**MEMO TO:** Giuliano La Moglie, Planner II – Development  
**FROM:** James Pavlidis, Urban Designer

**SUBJECT: OFFICIAL PLAN AND ZONING BY-LAW AMENDMENT**

**Applicant Name:** Brutto Consulting  
**Municipal Address:** 9947 Leslie Street  
**Legal Description:** Part of Lot 20, Concession 3, E.Y.S.  
**City File No.:** OPA 23-0007  
**Related City File No.:** ZBLA 23-0011

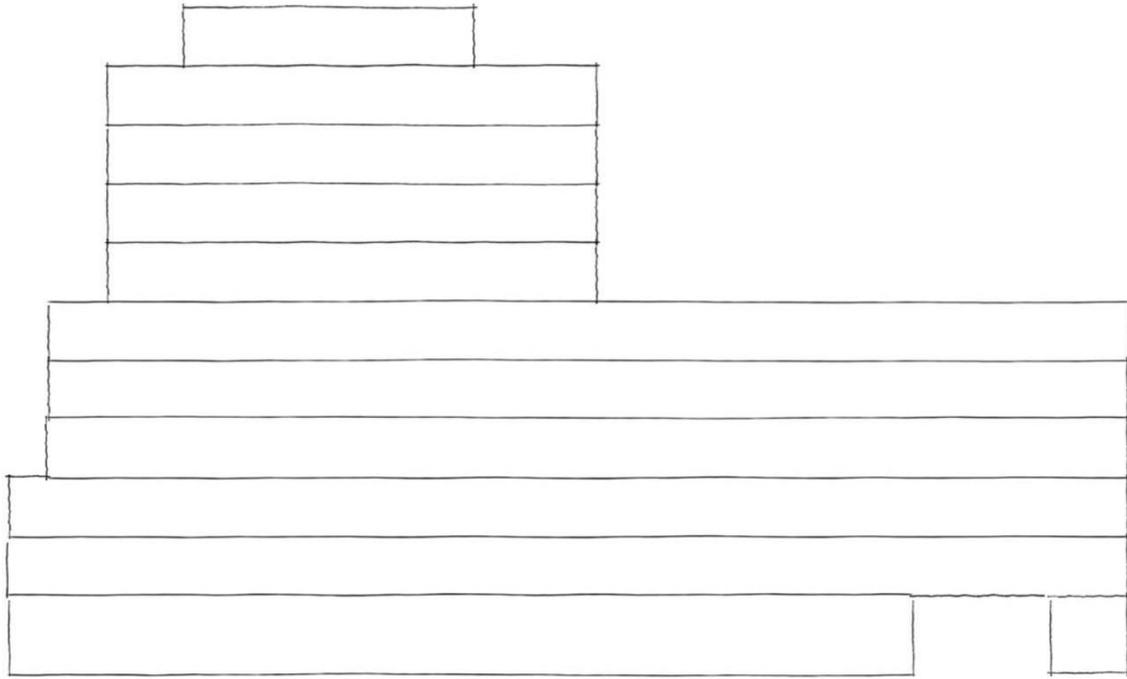
Issue	Comments / Recommendations	Policy / UDG Ref.
4. Massing	The current massing results in a bulky built form, particularly along the Leslie St frontage. The applicant should explore opportunities to sculpt the building with a view to achieve a more slender 'Tower' form and floor plate of approximately 750sq.m. See appended sketch for inspiration.	<b>OP 3.4.1.57, UDGs 6.6.42, 6.6.44</b>

Explore opportunities to sculpt the building with a view to reduce the appearance of bulky massing and achieve a slender built form, that is appropriately articulated and which complies with the tower separation policies of the Official Plan.
